745 THURLOW STREET (COMPLETE APPLICATION)  
DE413483 - ZONE CD-1 (493)

**DEVELOPMENT PERMIT STAFF COMMITTEE RECOMMENDATION: APPROVE**

**BUILDING  
 ELEVATION -  
 NORTH (ALBERNI ST)**

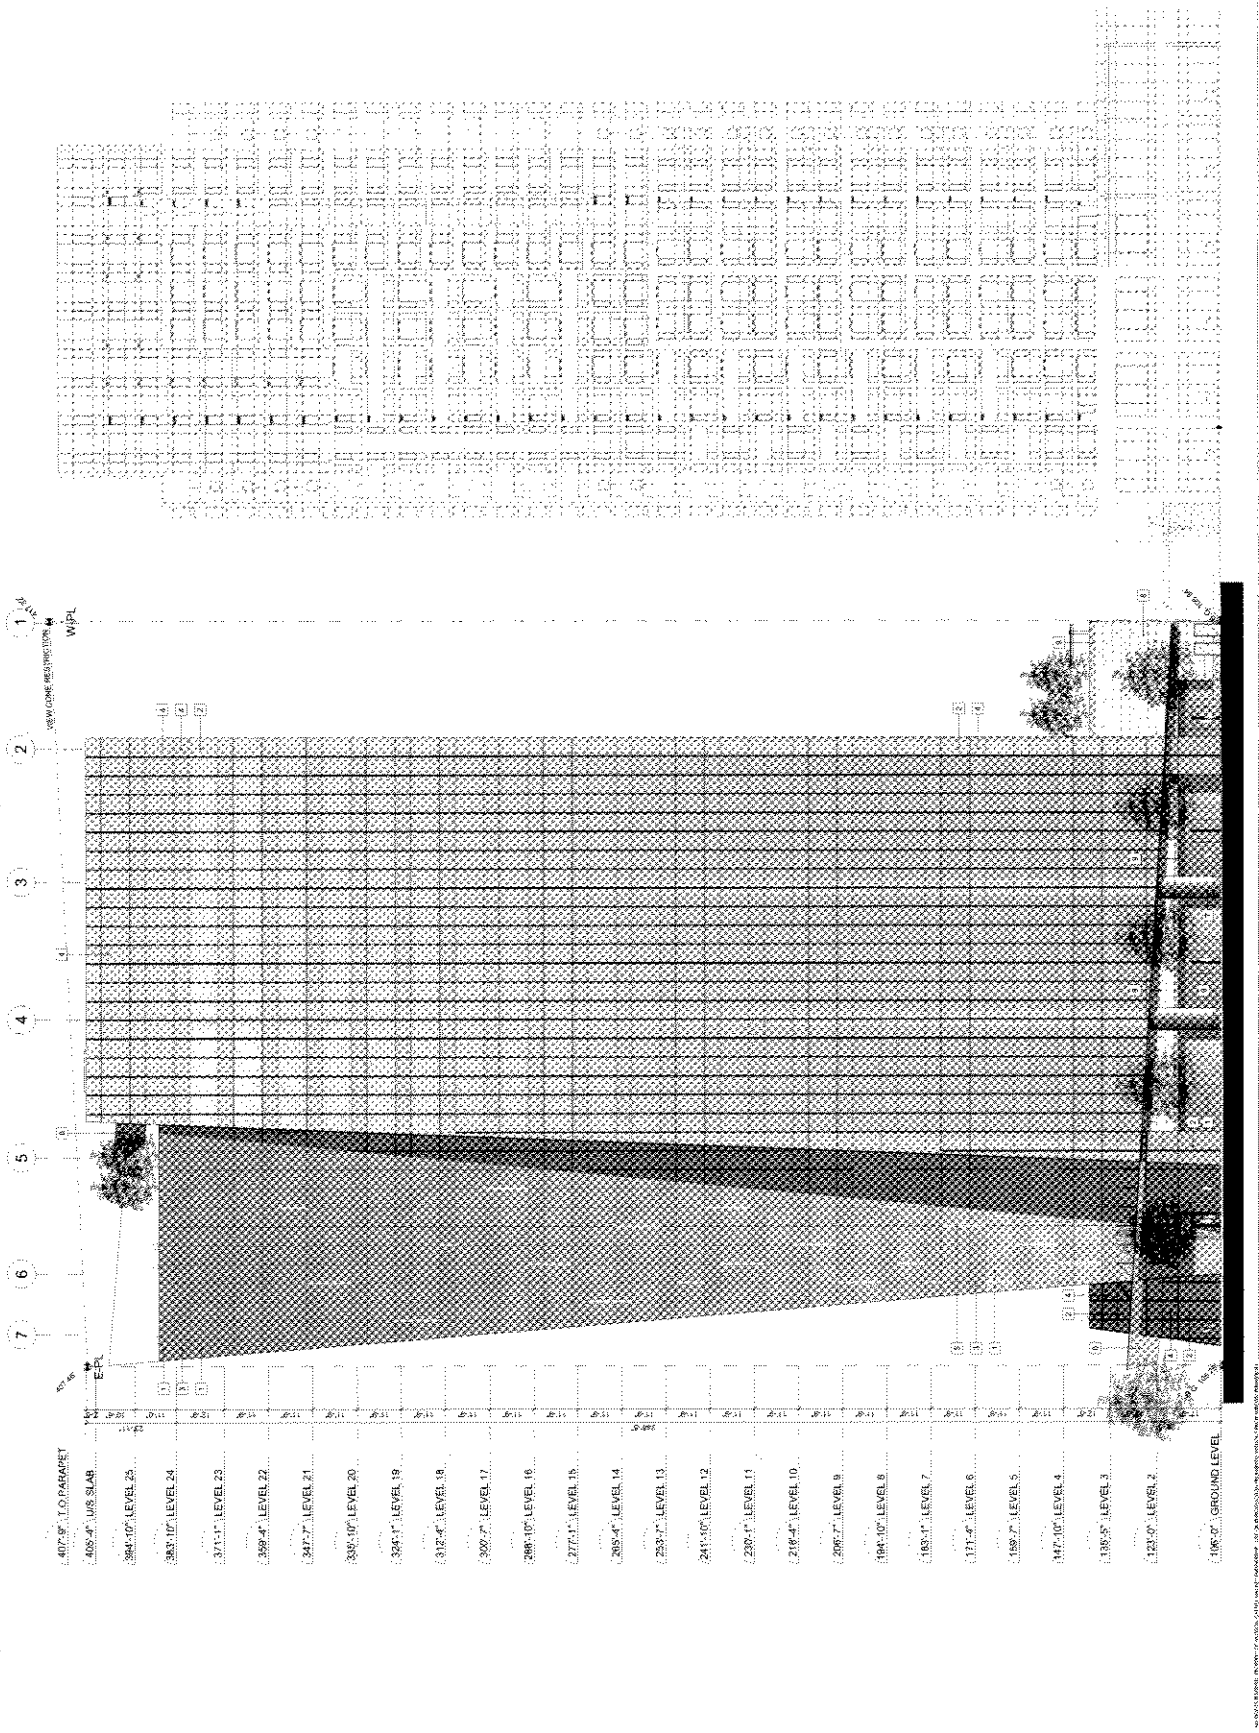
- Refinements to the treatment of the building frontage (ground floor) on Alberni Street.

**Note to Applicant:** Full size mock-up of this juncture should be considered.
  - 1.2 design development to refine the treatment of the Alberni Street ground floor building frontage;

**Note to Applicant:** Pursuing an expression more consistent with the project's overall architectural language should be considered.
  - 1.3 design development to incorporate intermittent trellises and/or a row of trees on the podium roof deck (lane and Thurlow Street sides).
- 2.0 That the conditions set out in Appendix A be met prior to the issuance of the Development Permit.
- 3.0 That the Notes to Applicant and Conditions of the Development Permit set out in Appendix B be approved by the Board.

The street frontages have improved in response to the condition. The Urban Design Panel expressed a concern with the character of the Alberni Street retail façade at the ground level and that it should be more consistent with the building's overall architectural language. Staff concur that further refinements should be pursued (See Condition 1.2).

There was some concern regarding the ground plane on Alberni Street. The Panel noted that the treatment was different from the other elevations and felt it should have the same architectural language. A Panel member suggested the LED lights on the building could show up in the landscape treatment which would help to animate the ground plane. Another Panel member was concerned with the cantilevered face of the building with the second level deck and the potential for vertigo in people using the space. It was suggested that a trellis or tree canopies over the seating area would make for a more comfortable space. The Panel members liked the landscape noting there was a continuous thought to the patterning and as well various outdoor rooms had been created. The one area on the upper floor that needs a little more development is the relationship between the interior amenity space and the outdoor space. The only door to the outside from the actual amenity space is on the north side and there is no connection on the south side.

LANDSCAPE PLAN  
Level 1

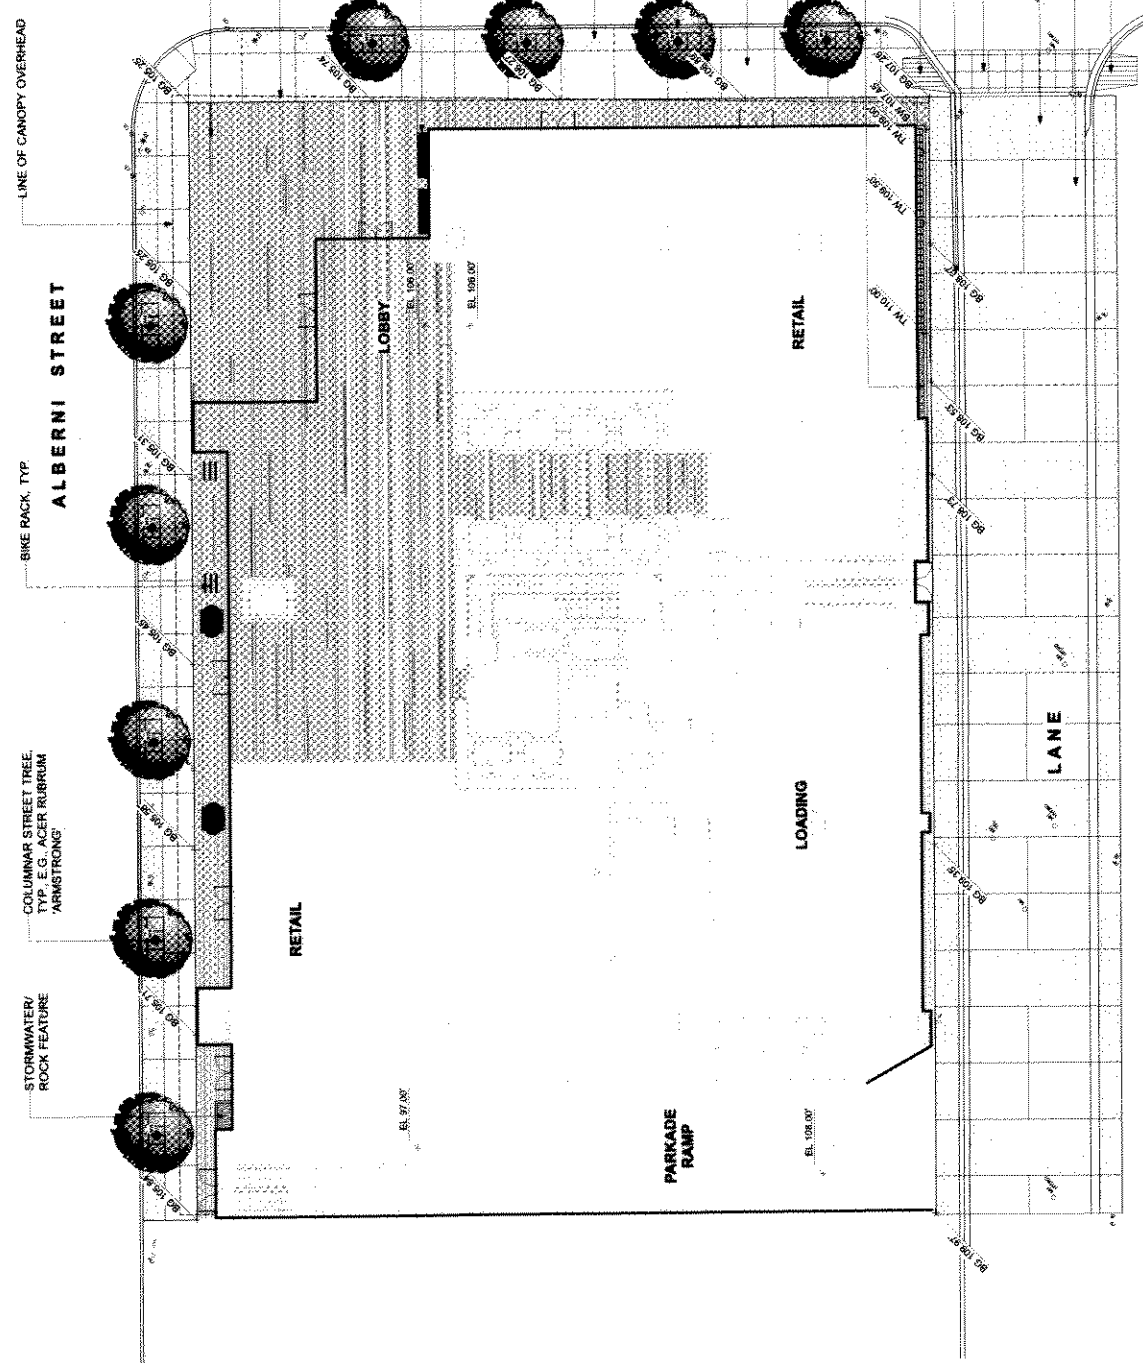
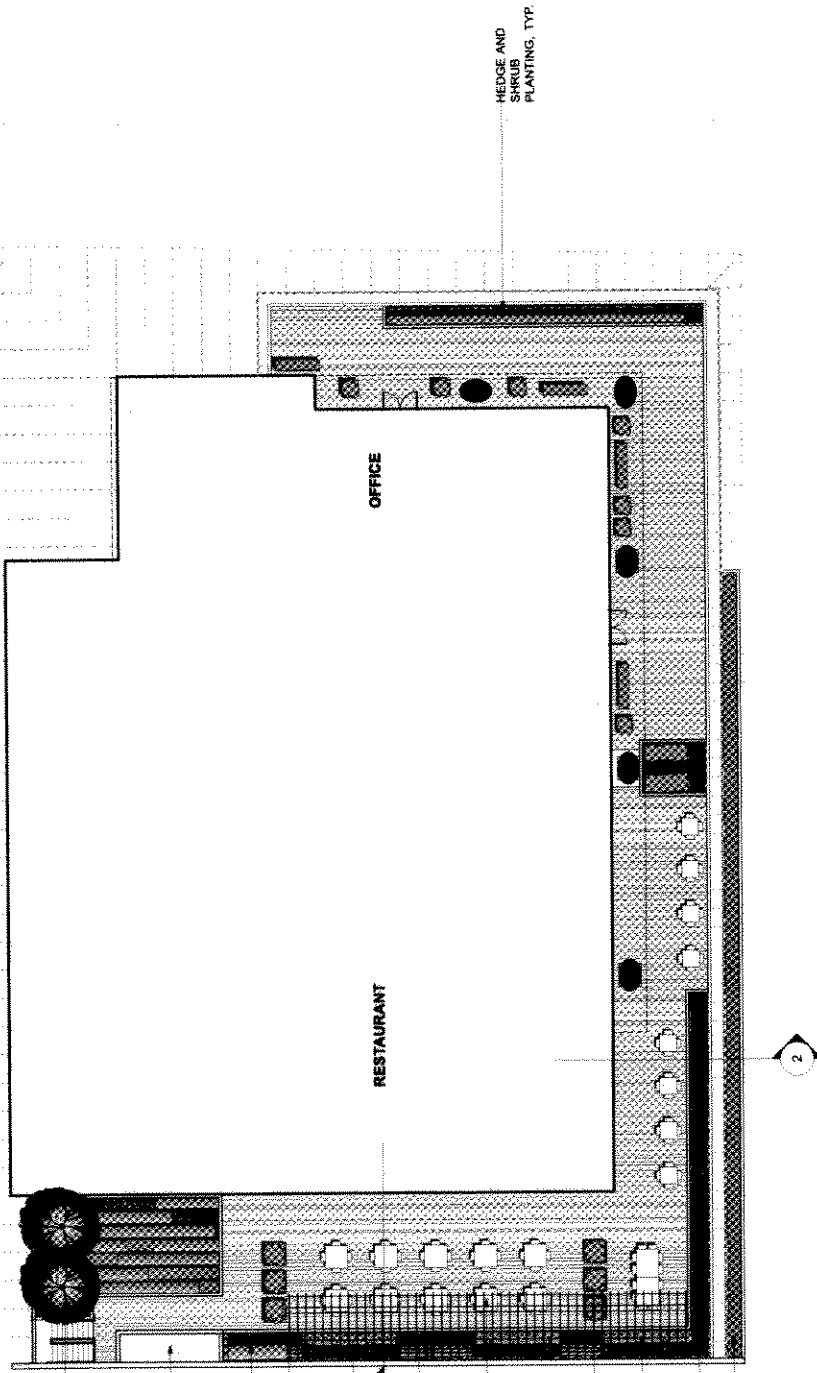
A.1.8 provision of a full planting plan for pages LDP 1.02 and 1.03;

**Note to Applicant:** All plants listed on the Plant List should be individually located and identified on the Landscape Plan.
